• **ENGINE—ROUGH IDLE/MISS AFTER START-UP DURING COLD AMBIENT TEMPERATURES LESS THAN -12 DEGREES C (10 DEGREES F)—VEHICLES BUILT 3/1/1996 THROUGH 7/31/2000** • **NOISE—FROM ENGINE—ROUGH IDLE/MISS AFTER START-UP DURING COLD AMBIENT TEMPERATURES LESS THAN -12 DEGREES C (10 DEGREES F)—VEHICLES BUILT 3/1/1996 THROUGH 7/31/2000**	**Article No. 00-26-1**

FORD: 1997-1999 F-250 LD
1997-2000 ECONOLINE, EXCURSION, EXPEDITION, F-150
1999-2000 F SUPER DUTY

ISSUE

Figure 1 - Article 00-26-1

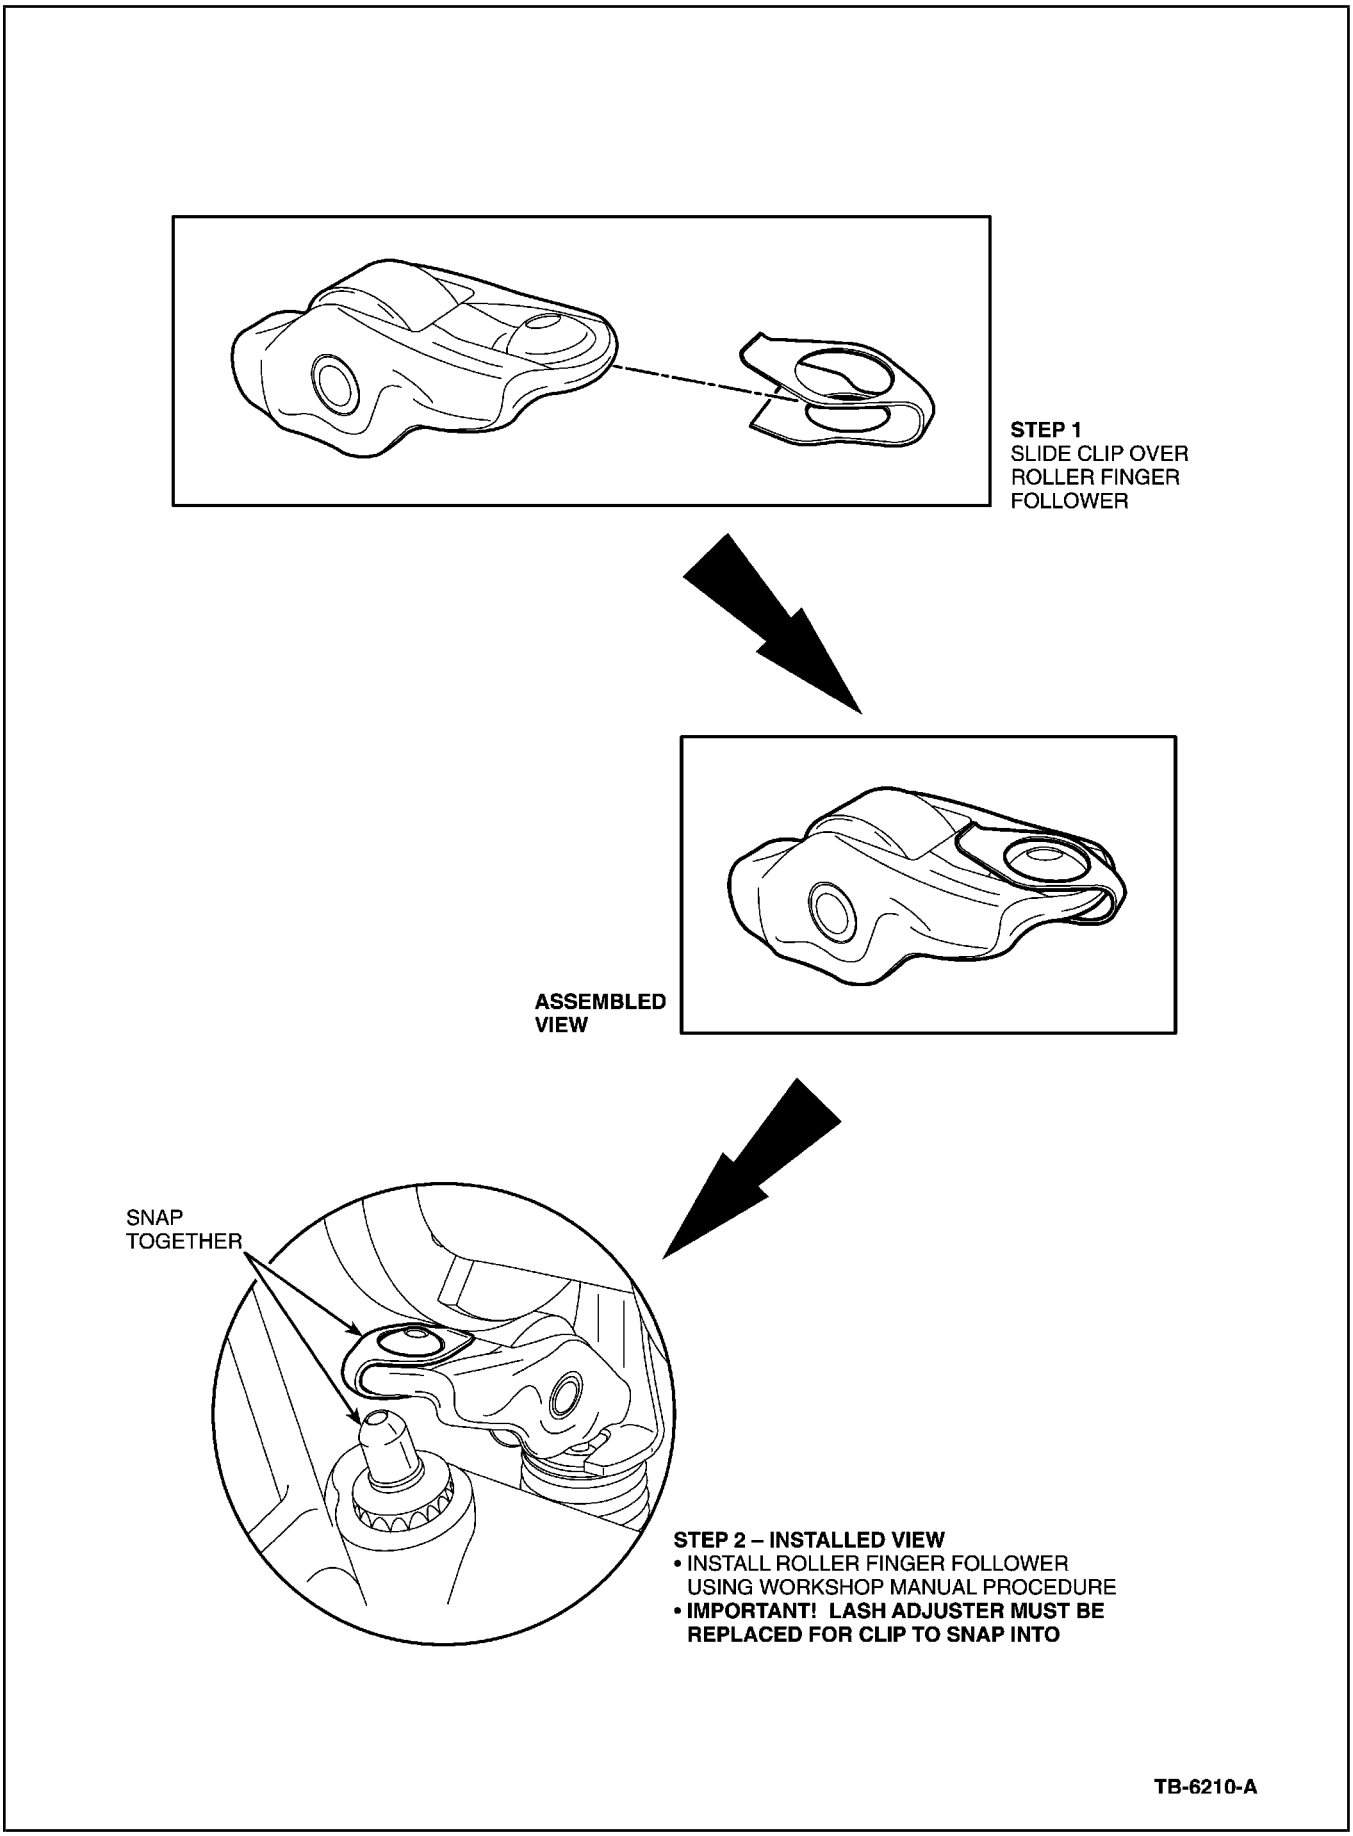
NOTE
REFER TO FIGURE 1 FOR INSTALLATION OF THE NEW RETAINING CLIPS (YL3Z-6A539-AA), TO THE ROLLER FINGER FOLLOWER.

4. Using a valve spring compression tool, install followers and the attached retaining clips by pushing clips onto lash adjuster.

NOTE
THE CLIP IS NOT REMOVABLE FROM ADJUSTER ONCE IT HAS BEEN SNAPPED INTO PLACE. IF THE ENGINE NEEDS TO BE SERVICED AT A LATER DATE, REMOVE THE RFF BY BENDING UP THE CLIP. LEAVE LASH ADJUSTER IN THE ENGINE WITH THE CLIP WHILE REMOVING THE FOLLOWER. THEN REMOVE THE LASH ADJUSTER FROM THE HEAD AND SNIP/CUT THE CLIP FROM THE LASH ADJUSTER. REPLACE WITH A NEW CLIP ON FOLLOWER DURING INSTALLATION.
